S-12-03

TO: City of Pueblo, Planning and Zoning Commission

SUBJECT: **Baca and Son Subdivision**

RECOMMENDED MOTION: Move that the requested Subdivision be **APPROVED** with the following noted:

Baca and Son Subdivision

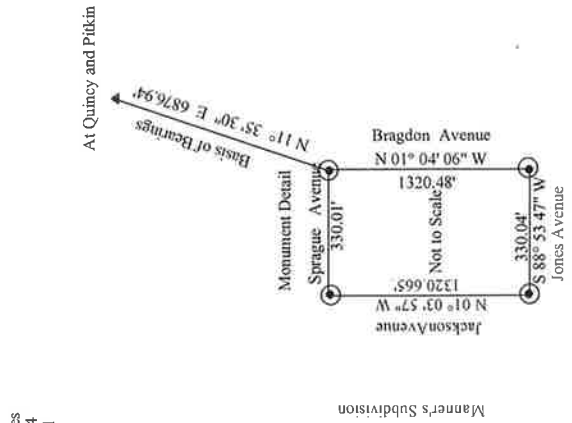
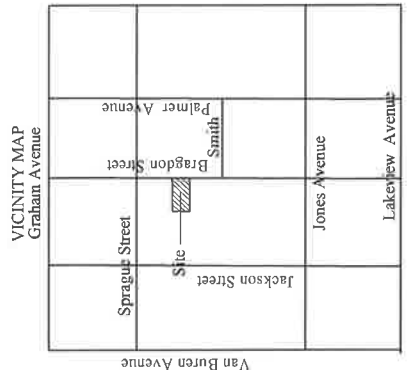
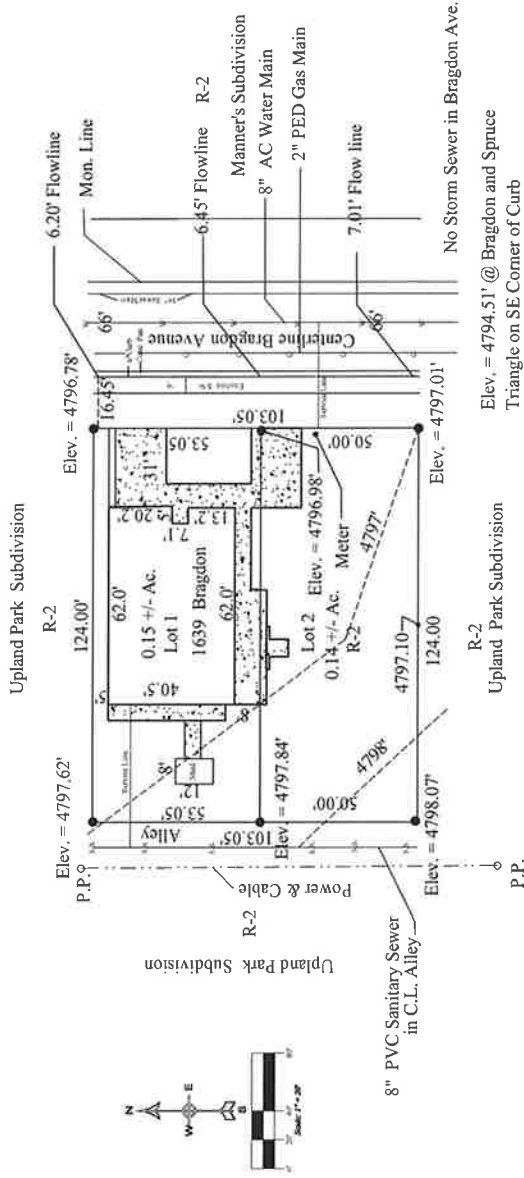
- The following plat statements need to be in our current language form:
The statement that begins “KNOW ALL MEN BY THESE PRESENTS:”
The statement that begins “HAS CAUSED”
The PLANNING AND ZONING CERTIFICATION statement.
The CITY ENGINEERING Statement
The CITY APPROVAL Statement
- The dedication statement for public utilities is not required for this subdivision. This statement is to be removed.
- Jess Baca Jr.’s name is shown incorrectly in the dedication portion of the plat. (J. Martellaro, 6/21/2012)

- Regional Building – water and sewer connections cannot cross parcel lines; each lot must have own taps. (M. Colucci, 6/7/2012)

- Since the water service line to the existing structure will front future Lot 2, a new tap and service line will be required for future Lot 1. Lot 2 will be able to use the existing tap and service line. (L. Huffstutter, 5/22/2012)
